| C/FM SC FM  | P 1   | L 25               | # 1        |        | C/ 116                       | SC 116.1  | .4  | <sup>⊃</sup> 28                          | L 8   | # 4   |
|---|---|--------------------|------------|--------|------------------------------|---|---|--|---|---|
| "IEEE Std 802.3-202><br>SuggestedRemedy   | <" is no lomnger correct - we k                               | now it will be 202 | 22 release |        | 400GB                        | ASE-Z optica                                      | han the defined marg<br>al PHYs. Note that 40<br>3BASE-Z as defined   | 0GBASE-                                  | -ZR is part of the  | eate a new table for<br>family of physical layer                |

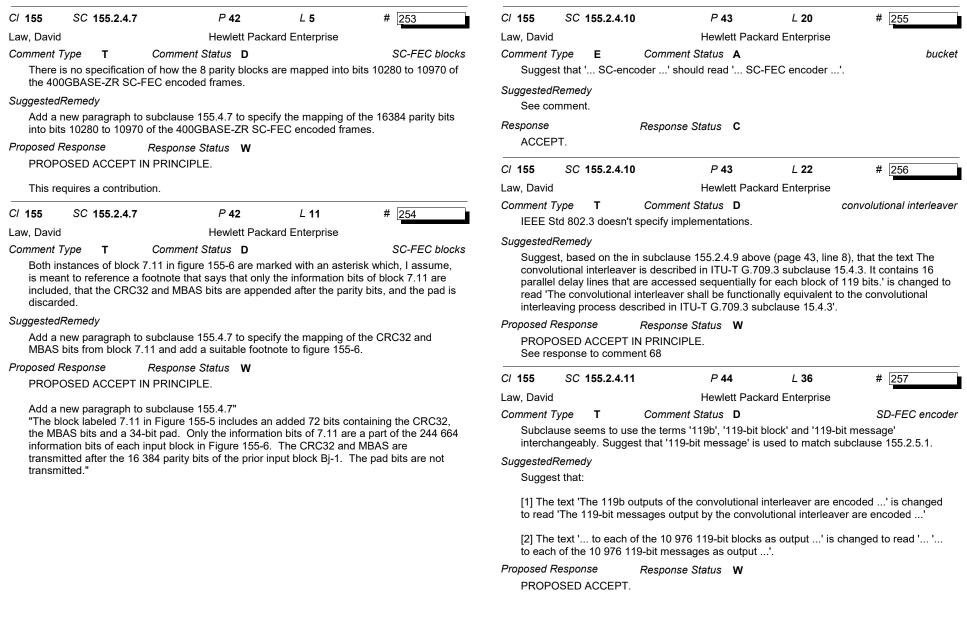
The 31 symbols after P0 shown for sub-frame 1 in Figure 155-12 are ts<0:10>, but P0 overlaps ts<0>, so this is 10 bits, followed by m<3488:3508> which is 21 bits resulting in a

total of 31 bits. The 42 symbols after P0 shown for sub-frame 48 in Figure 155-12 are ts<0:10>, but P0 overlaps ts<0>, so this is 10 bits, followed by m<172 030:172 061> which

Figure 155-12 are m<3509:3539>, the 32 symbols after P1 shown for sub-frame 48 in

Sub-frames 1 through 48 are the same format. See the response to comment 244, which corrects the length of the payload before P1 in sub-frame 48 of Figure 115-12.

The fourth paragraph of 155.3.3.3 mentions that the first symbol of TS, i.e., ts<0> has the same value as the corresponding PS symbol, i.e., P0, for each polarization and is counted as a pilot symbol.

In order to emphasize this fact, move the 4th paragraph to after the first paragraph.

After the paragraph that starts "The first sub-frame.", add a new sentence: "Note that ts<0> and P0 are a single symbol, resulting in a count of 3712 symbols for the first sub-frame."

After the paragraph that starts "The next 48 sub-frames.", add a new sentence: "Note that ts<0> and P0 are a single symbol, resulting in a count of 3712 symbols for each of the next 48 sub-frames."

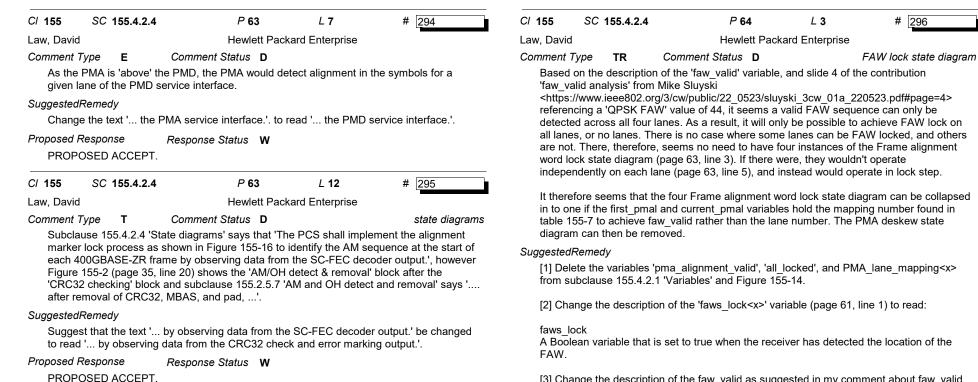
[2] Change the condition on the transition from the 'COUNT\_2' state to the 'COMP' state in Figure 155-14 'Frame alignment word (FAW) lock state diagram' to read 'faw\_counter\_done \* faw\_valid'.

[3] Add a transition from the 'COUNT\_2' state to the 'INVALID\_FAW' state in Figure 155-14 'Frame alignment word (FAW) lock state diagram' that reads 'faw\_counter\_done \* !faw valid'.

Delete the 'cw bad count' counter definition.

PROPOSED ACCEPT.

[3] Change the description of the faw valid as suggested in my comment about faw valid.
